Engineering Assessment Report

Proposed Large-Scale Residential Development (LRD) at Old Slane Road, Mell/Tullyallen, Drogheda, Co. Louth

Waterman Moylan Consulting Engineers Limited

Figure 6.2– Visibility of pedestrians using shared surface

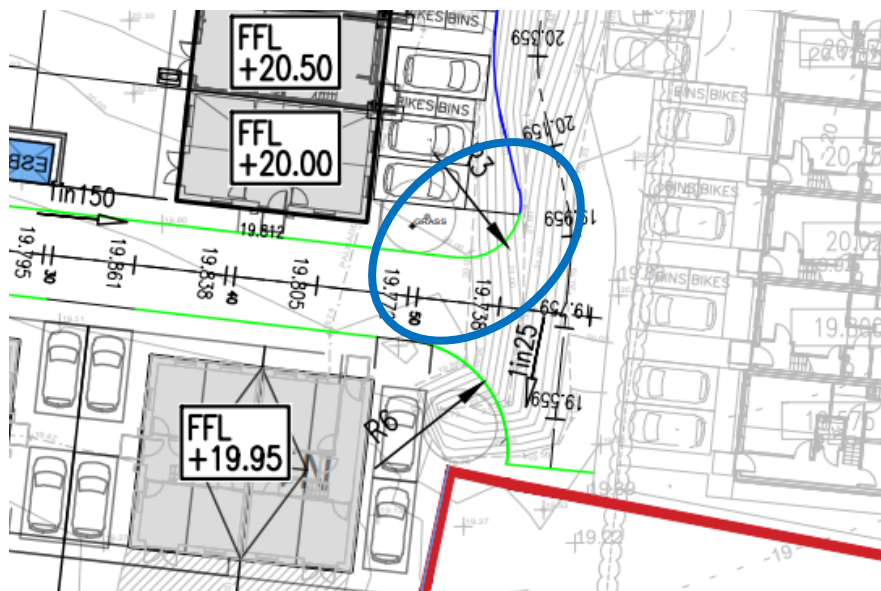
6.3 Issue

Shared surfaces are proposed within the development where pedestrians will be interacting with vehicular traffic. It is unclear if adequate stopping sight distance for motorists to a pedestrian will be provided in all areas of the shared surface. A lack of appropriate stopping sight distance may contribute to a pedestrian collision in these areas.
